ADDENDUM NUMBER TWO

**Langan Park – Amphitheater Pavilion & Restroom
Project No: PR-031-21**

**Public Safety Memorial Park
Restroom, Skateboard Park & Splashpad**

OCTOBER 24, 2022

**SHEET TITLE
SYMBOLS, ABBREV.,
GENERAL NOTES &
REF. SITE PLAN**

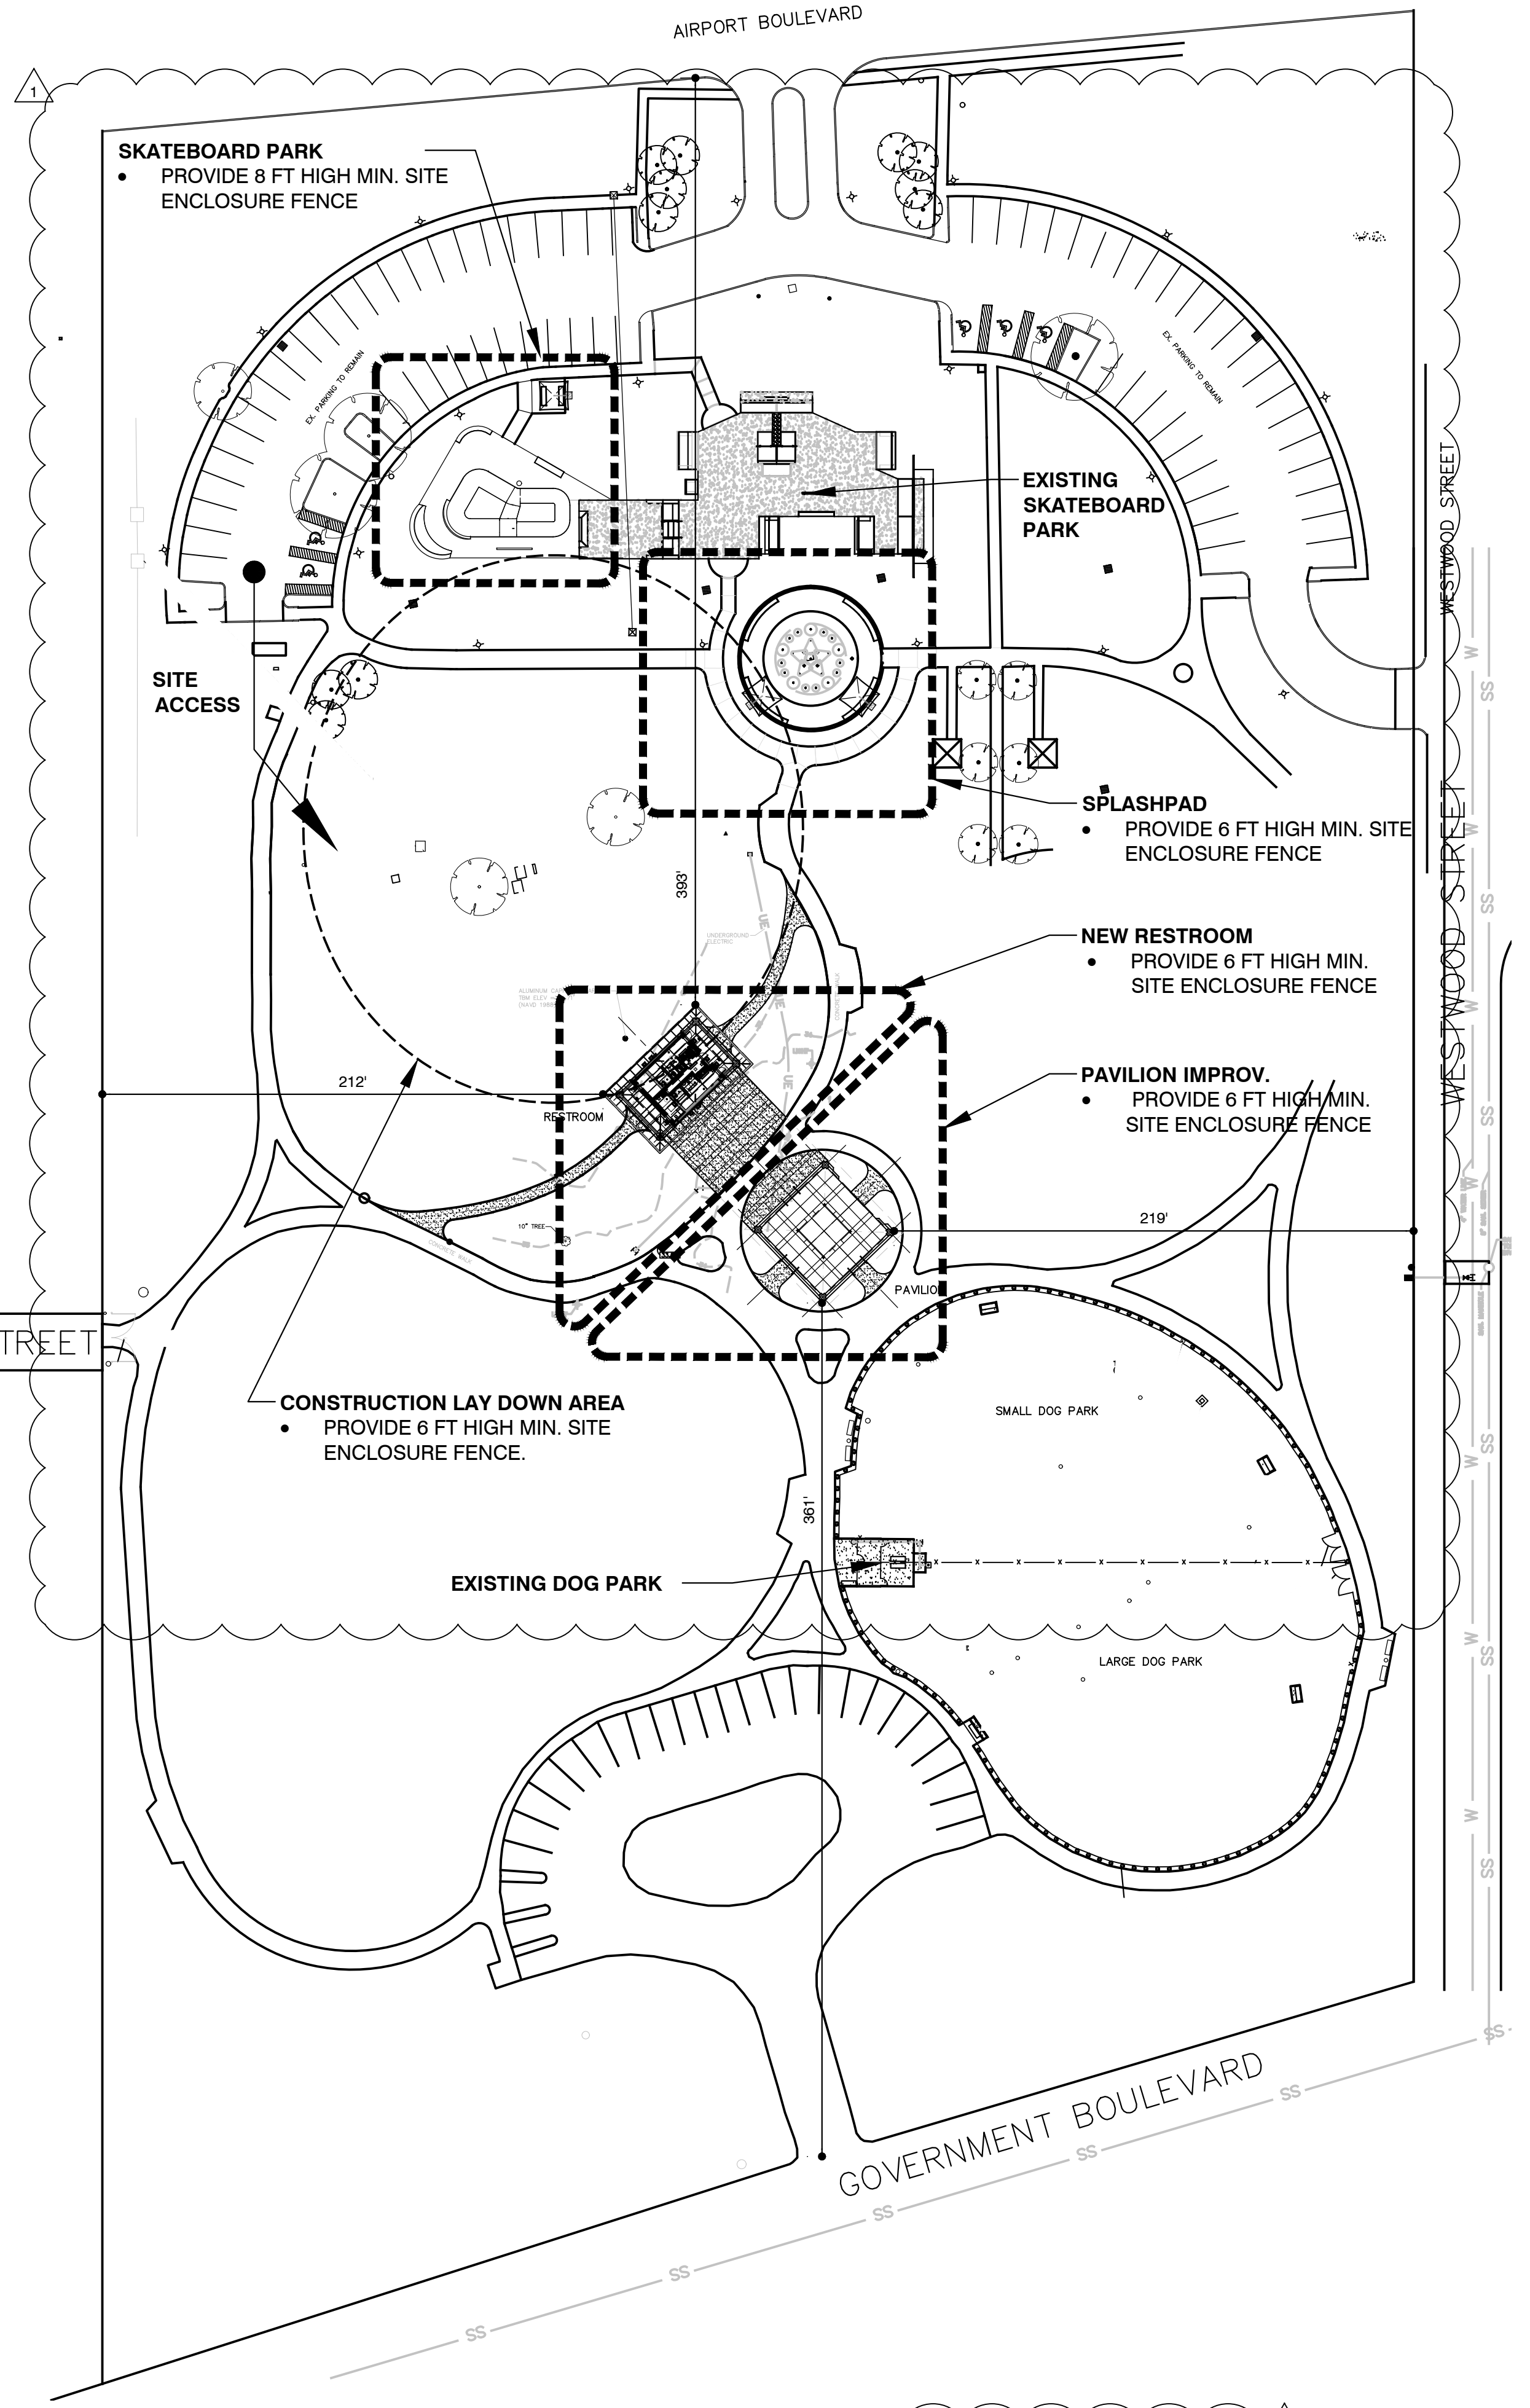
- 4.04 A. Replace G002 with attached *new G002 – Symbols, Abbreviations, General Notes* Addendum 02 dated October 24, 2022. Note site plan change made to site map to include Work Areas to conform to Bid Form Area Base Bids.
